City of Lafayette Memorandum

For:	Lafayette Downtown Strategy Advisory Committee Ann Meredith, Community Development Director
By:	Lafayette Parks, Trails and Recreation Commission, Jennifer Russell, Parks, Trails & Recreation Director
Date Written:	March 11, 2009
Subject:	**Park and Trail Proposals in Draft "Lafayette Downtown Strategy & Specific Plan" dated January 2009**

Subject: Downtown Draft Specific Plan
Date Written: March 11, 2009

Picture 2

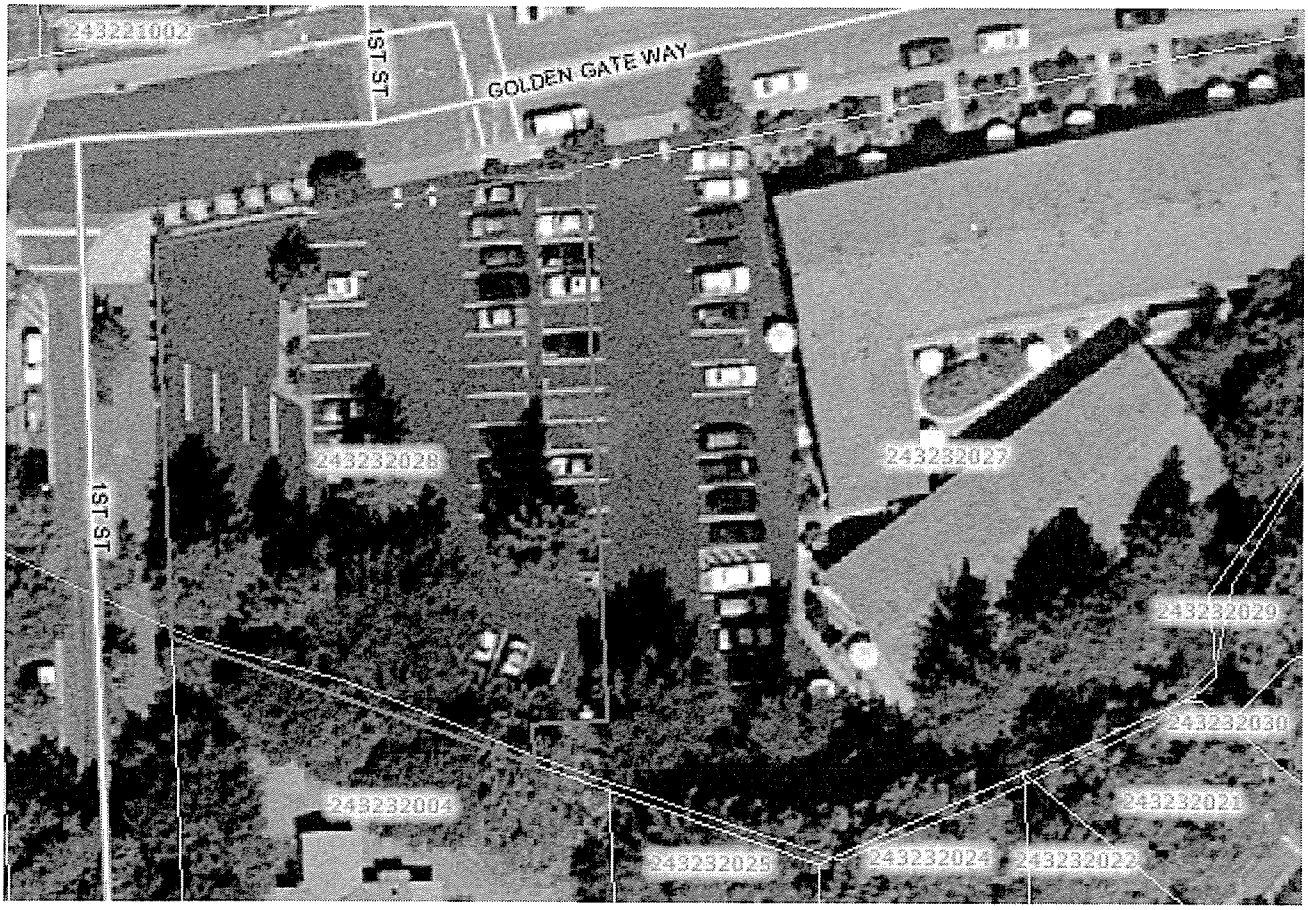
The Library Park is an active park with play equipment and picnic areas that relate to activities at the new library and the large population of school children frequenting the area. The Gazebo Park is a passive park that is also an integral gateway and connection to City and regional trails and bikeways.

PTR Commission Recommended
Library Park (Active)
